Southern California Edison
Circle City and Mira Loma-Jefferson PTC A.15-12-007

DATA REQUEST SET A1512007 ED-SCE-02

To: ENERGY DIVISION

Proposed Project Stripmaps

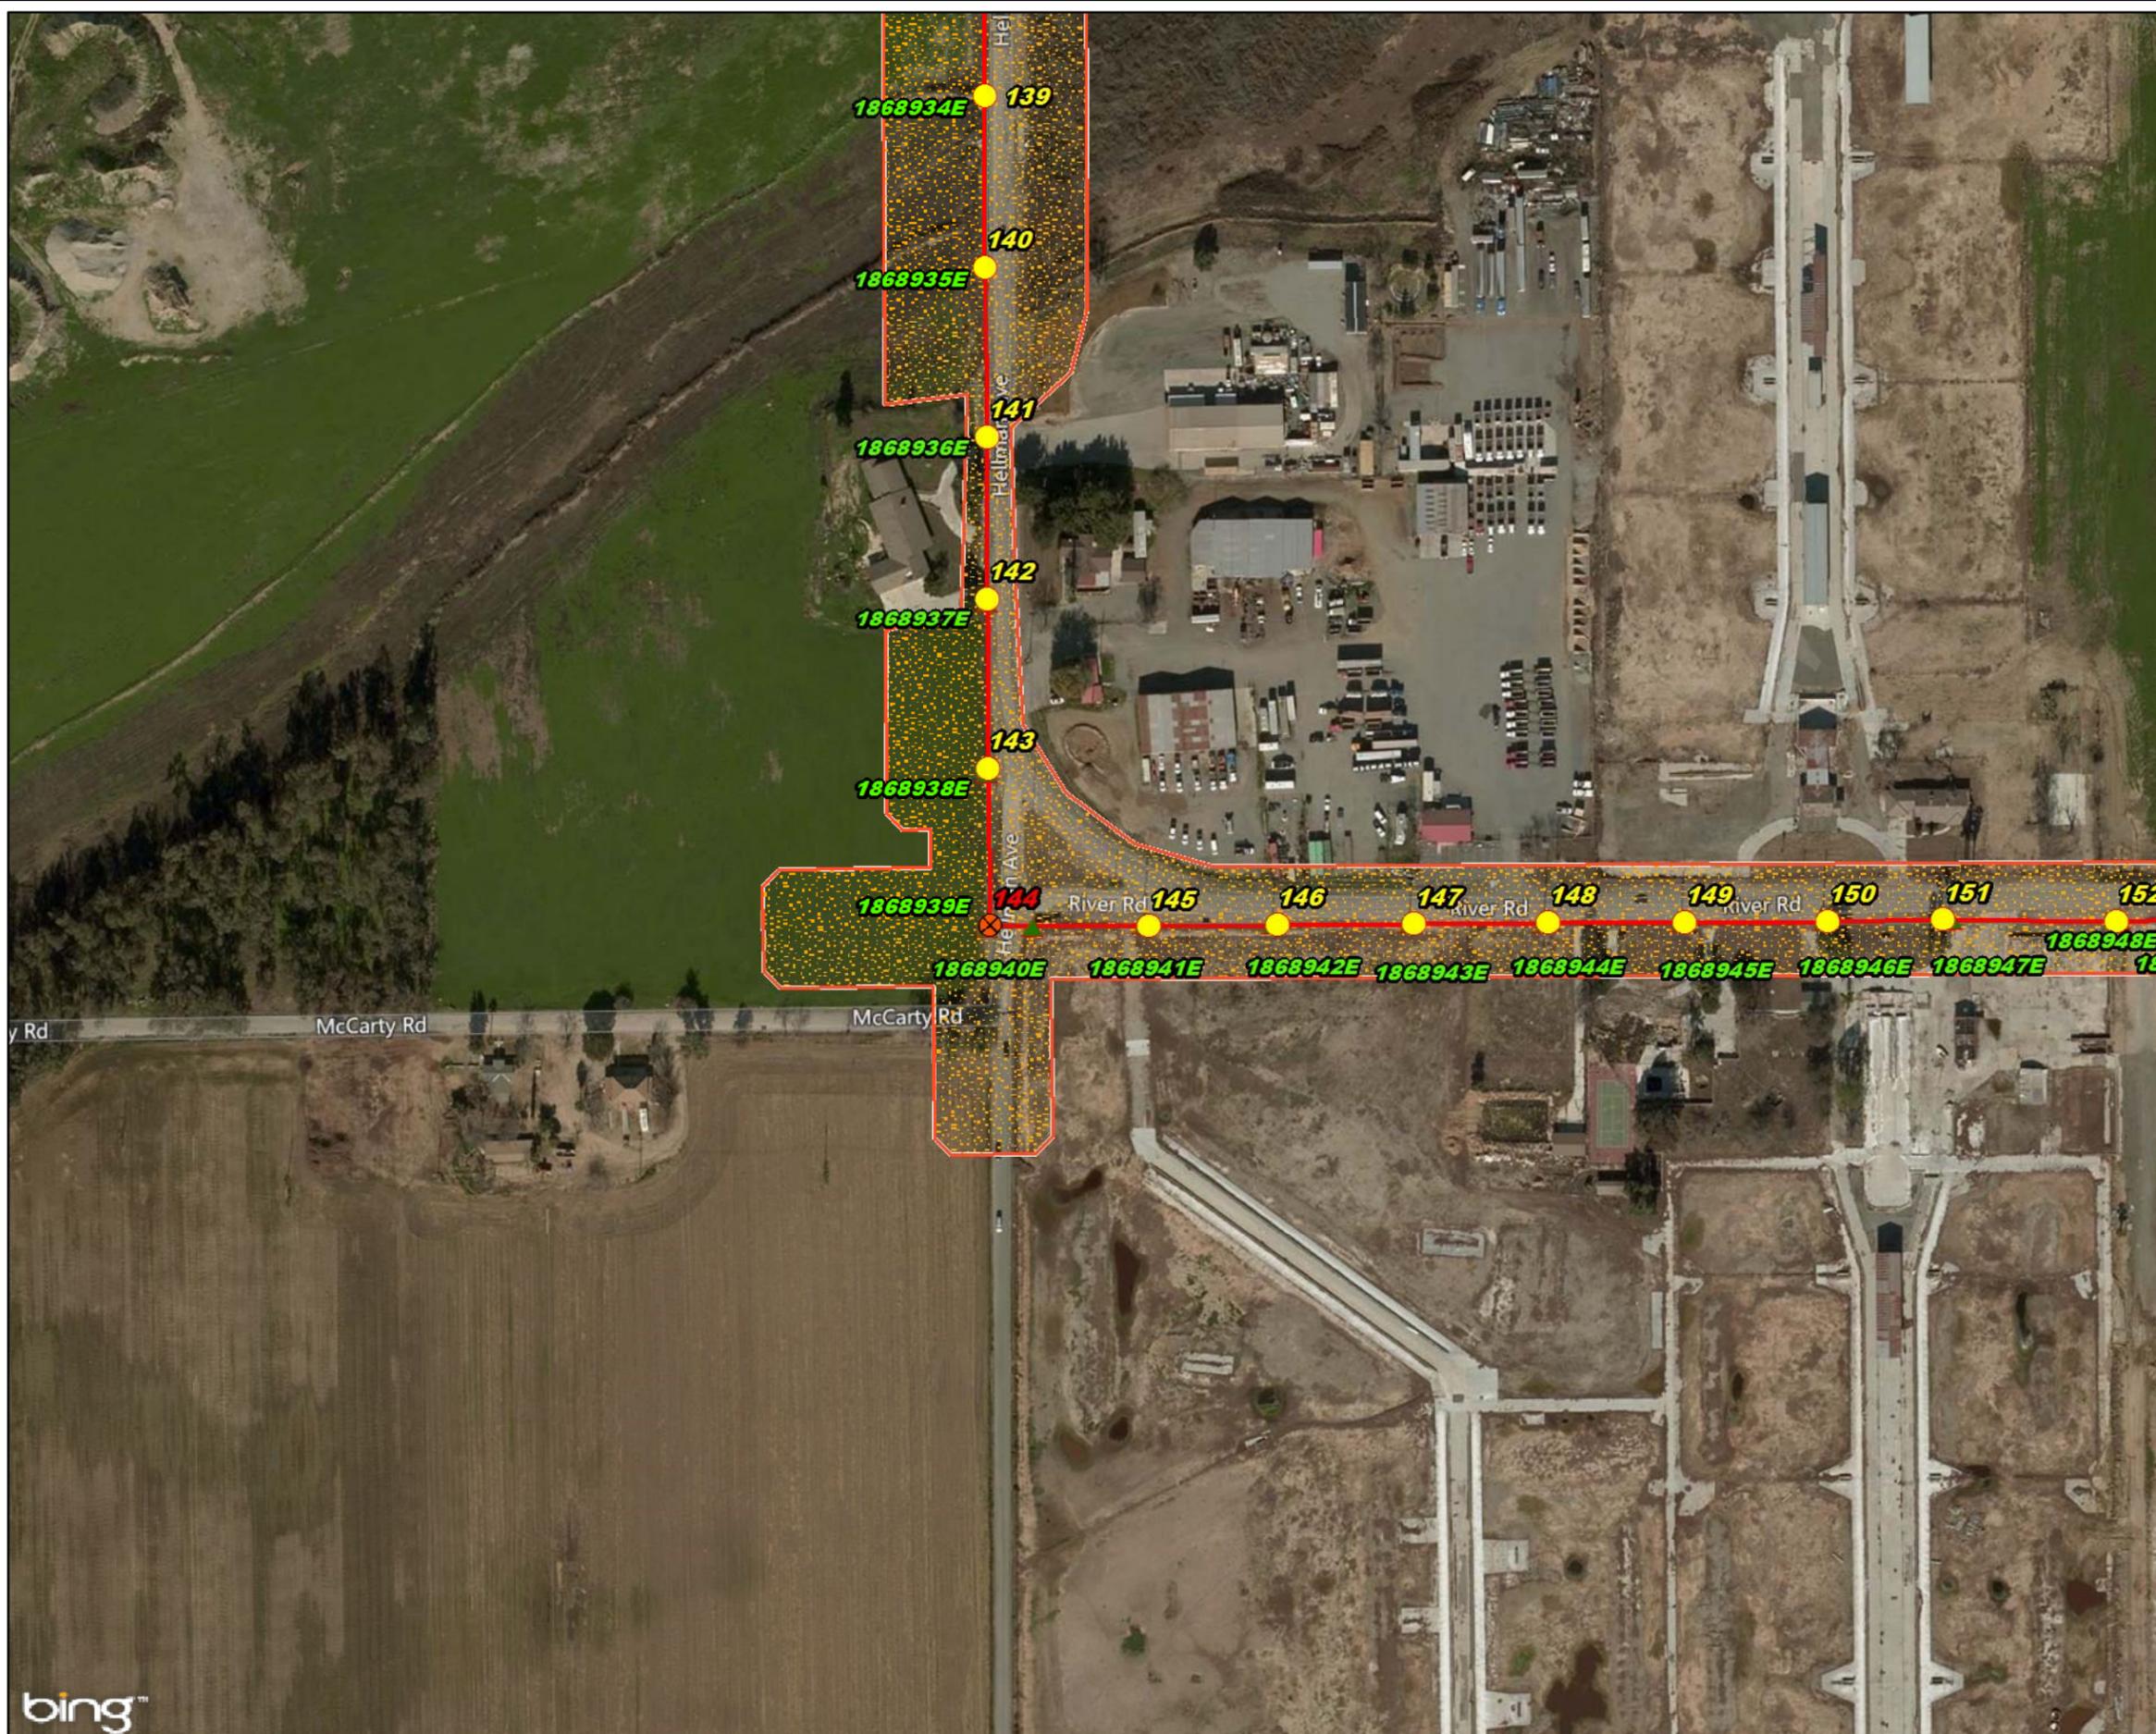
SCE's stripmaps dated 2/1/2016, indicate that proposed pole 144 would replace existing poles 1868939E and 1868940E, and that proposed pole 145 would replace existing pole 1868942E. Please confirm whether or not there is an existing pole 1868941E that would be replaced by the Proposed Project .

There is an error on the strip map, the correct relationships are as follows: proposed pole 144 will replace existing poles 1868939E and 1868940E, proposed pole 145 will replace existing pole 186941E, and proposed pole 146 will replace existing pole 186942E. Please see attached corrected strip map.

Proposed Project Stripmaps

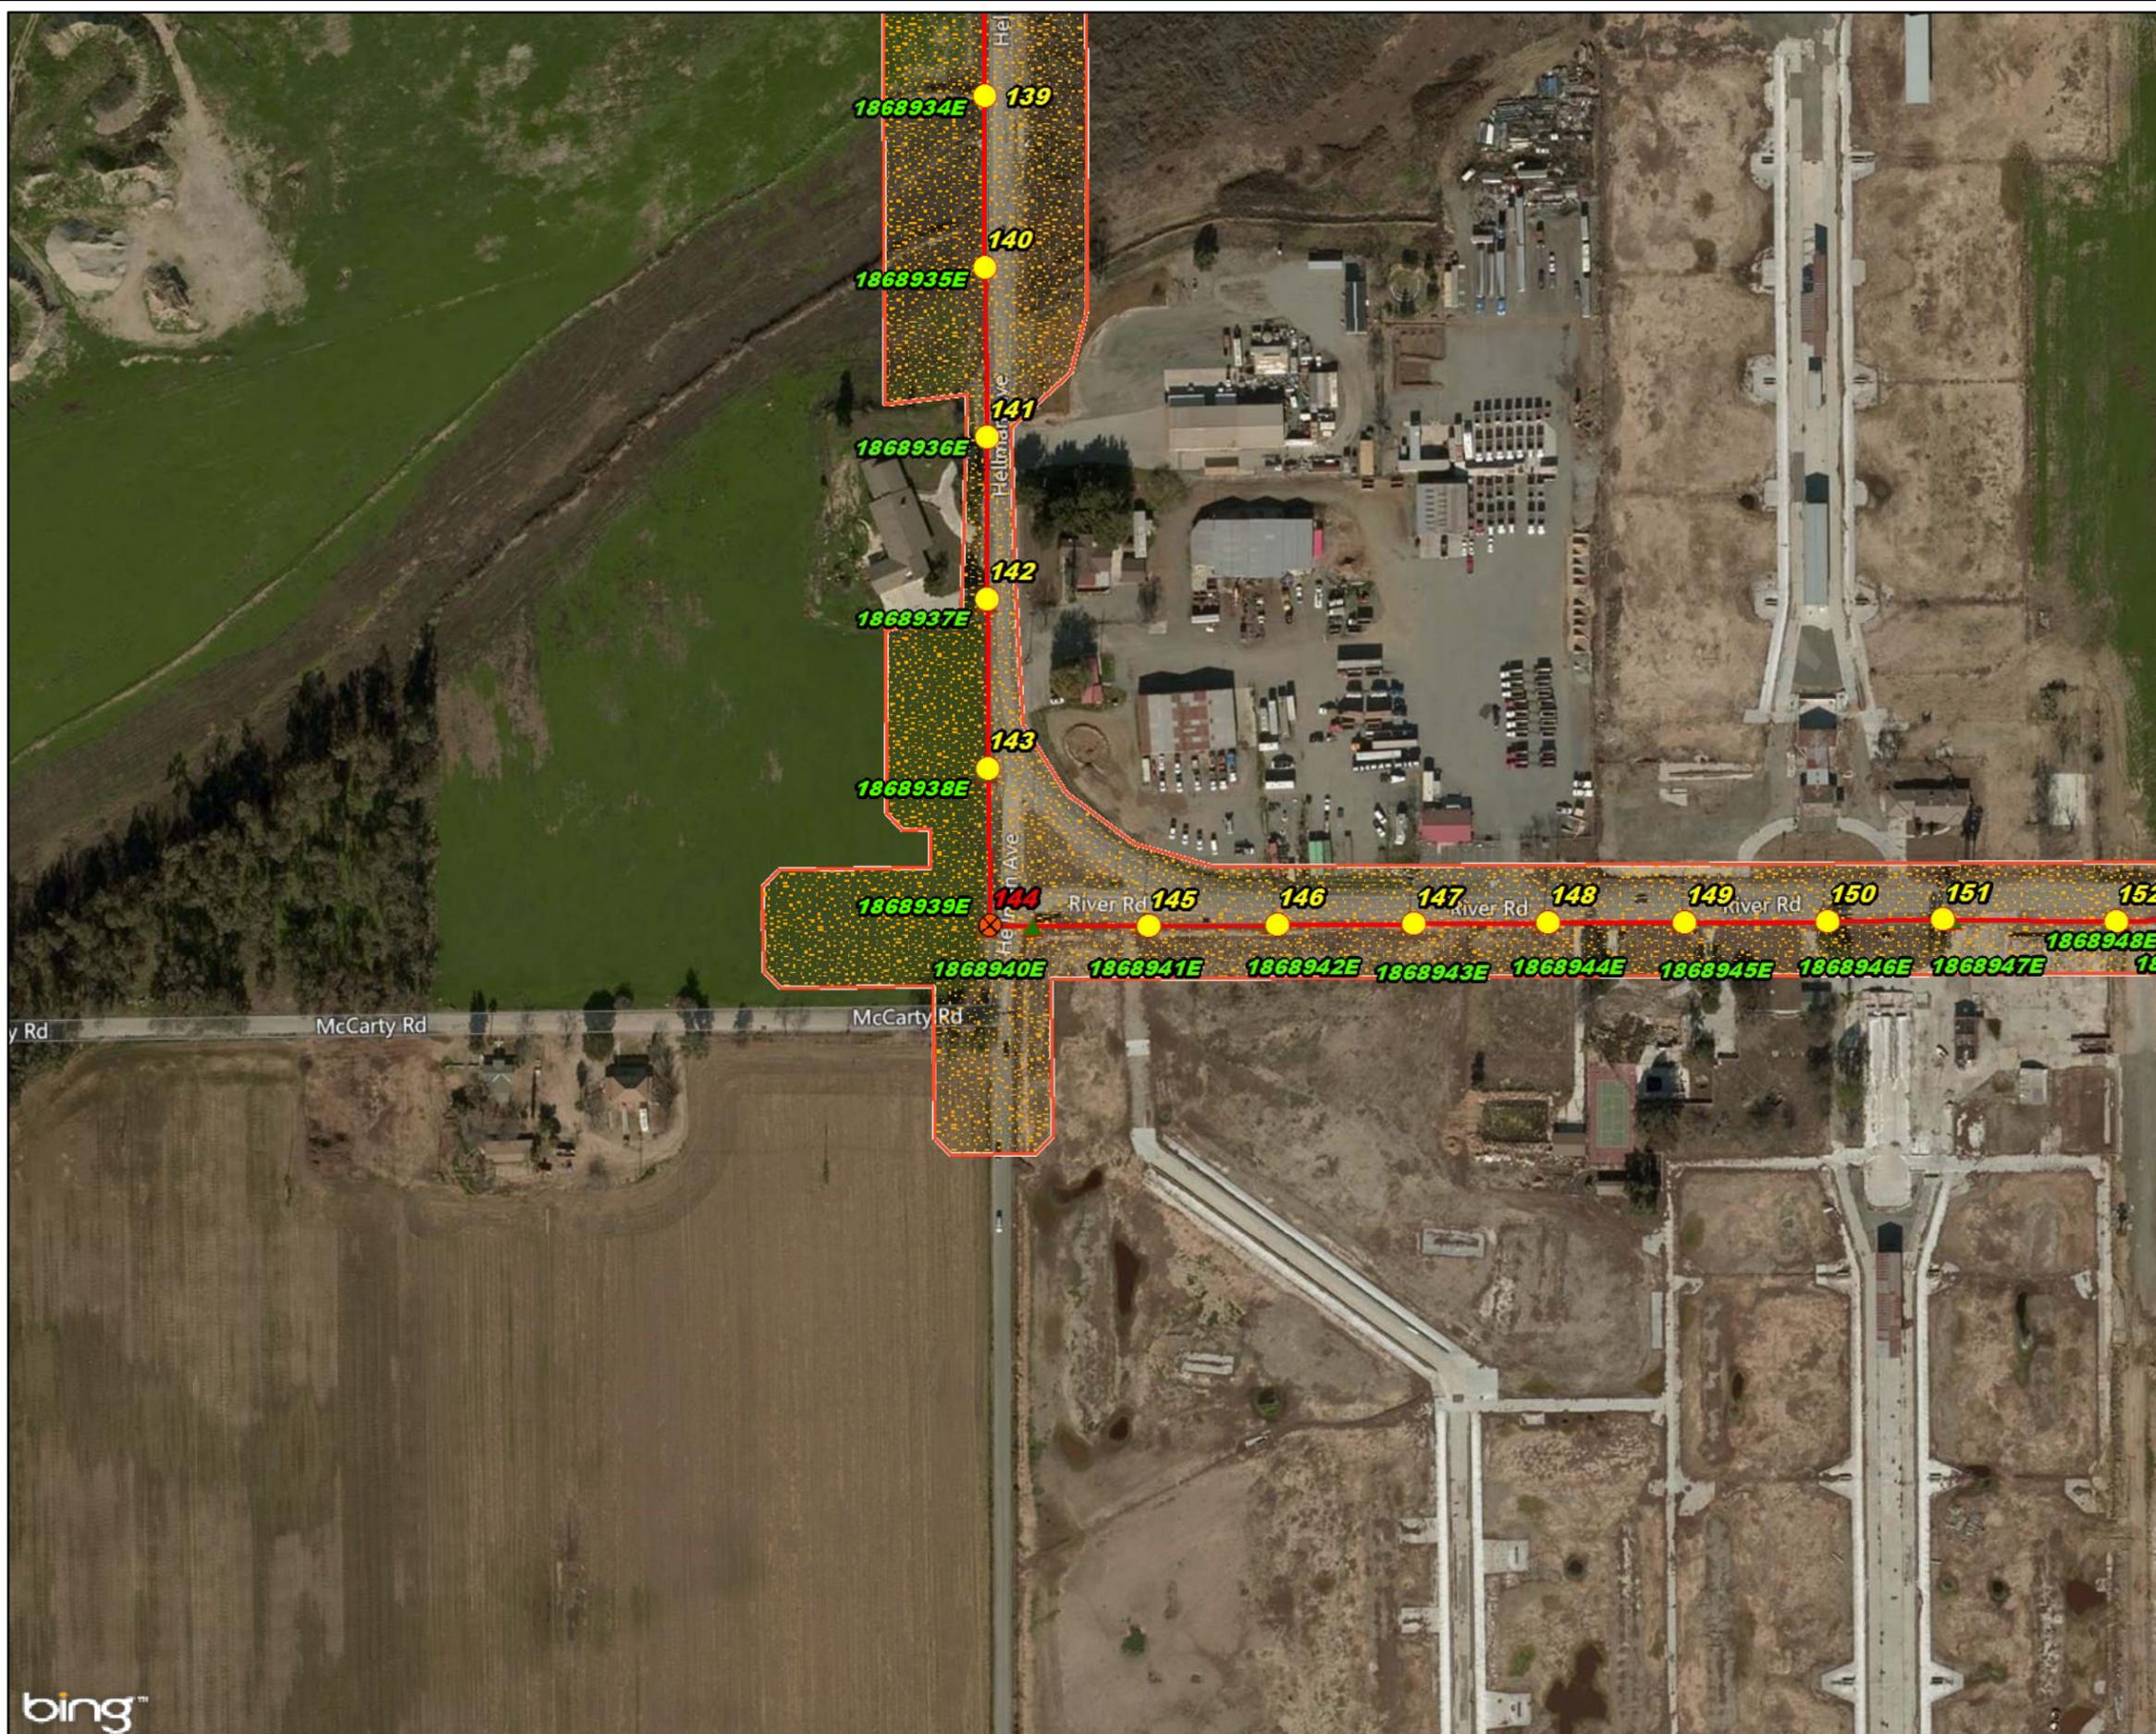
Page 17 of SCE's stripmaps dated 2/1/2016, indicate that proposed pole 151 would replace existing pole 1868948E; however, page 18 indicates that this existing pole would be replaced by proposed pole 152. Review of Google Earth satellite images indicate that there are existing poles at each of these proposed pole locations. Please confirm which existing pole would be replaced by proposed pole 151, and which existing pole would be replaced by proposed pole 152.

Proposed pole 151 will replace existing pole 1868947E. Proposed pole 152 will replace 1868948E. Please see attached corrected strip map.

Figure 200-1: Typical 69 kV Duct Bank

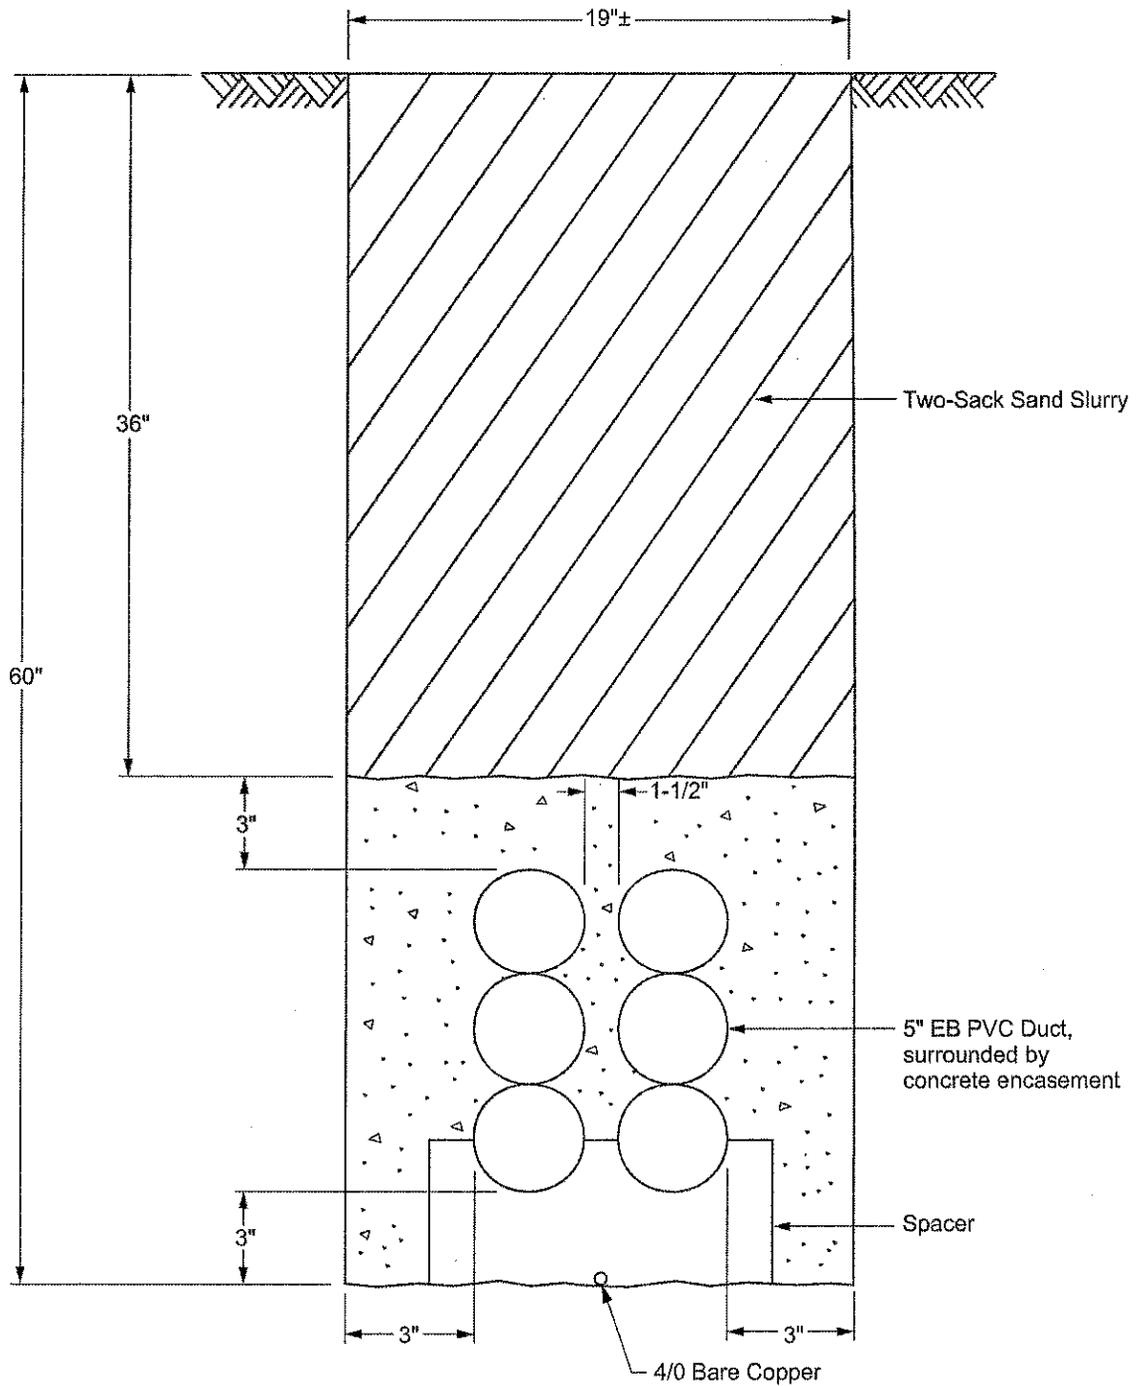
Please provide the original images used for PEA Figures 3-8, *Typical Subtransmission Duct Bank* , and 3-9, *Typical Subtransmission Vault* .

Please see the attached file that depicts the typical subtransmission duct bank and typical subtransmission vault. Should telecommunications facilities be co-located within the same duct bank as subtransmission, additional duct would be required to accommodate the telecommunications cable which is not seen in the attached typical depiction.
